WELL ABANDONMENT REPORT

P&A Proposal for the Argali Exploration Company Federal 24-2 Well located 983'FSL, 1380'FEL, Section 24, Township 3 South, Range 102 West 6th P.M. Rio Blanco, County, Colorado. Lease # C-0121348

CONDITIONS OF APPROVAL FOR PERMANENT WELL ABANDONMENT

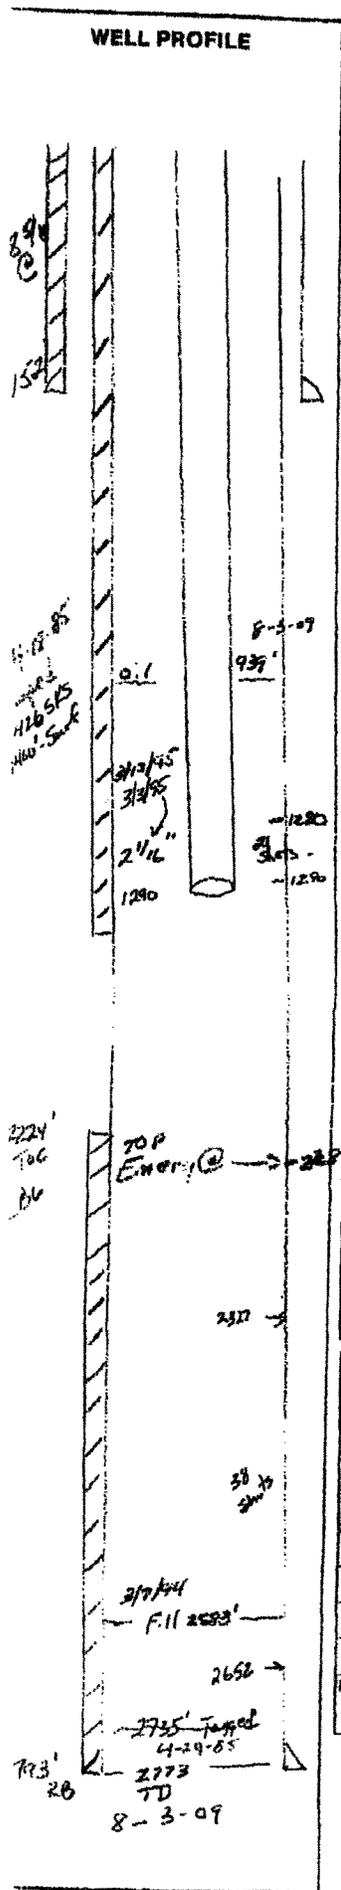
Per OO#2, G 2. Cased Hole. A cement plug shall be placed opposite all open perforation and extend to a minimum of 50 feet below (except as limited by TD or PBTD) to 50 feet above the perforated interval. All cement plugs, except the surface plug, shall have sufficient slurry volume to fill 100 feet of hole, plus an additional 10 percent of slurry for each 1,000 feet of depth. In lieu of the cement plug, a bridge plug is acceptable, provided:

- i. The bridge plug is set within 50 feet to 100 feet above the open perforations;***
- ii. The perforations are isolated from any open hole below; and***
- iii. The bridge plug is capped with 50 feet of cement. If a bailer is used to cap this plug, 35 feet of cement shall be sufficient.***

The submitted procedure has the CIBP above the Mancos perforations set 27' above the perforations and the CIBP above the Castlegate perforations set at 30' above the perforations. In order to comply with the passage from Onshore Order #2 above, the CIBP above the Mancos perforations must be set between 2227' and 2277' and the CIBP above the Castlegate perforations must be set between 1180' and 1230'.
